Town of Parker Community Development Department
Development Review Division
Attention: **Stacey Nerger & Mary Munekata**

Application Type: **Site Plan**
Status: **First Referral**
Application Name: **Parker & Pine L3 - Slim Chickens**
Case/AP#: **SP20-058**
Referral Received: July 30, 2020
Comments Due: August 28, 2020

Review date: **August 4, 2020**
Plan reviewer: **Randall L. Capra, rcapra@parkeronline.org**
Phone: 303.805.3169

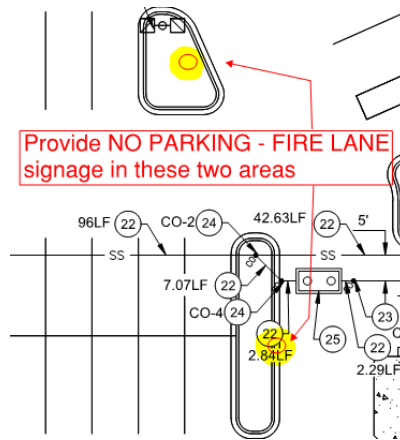
5. As discussed in each pre-application meeting, the applicant will need to provide a *fire hydrant in the area just west of the building* (in the island in front of the entry foyer).

Note – With respect to this project, access is provided though occupant loading dictates that the building is to be sprinklered.
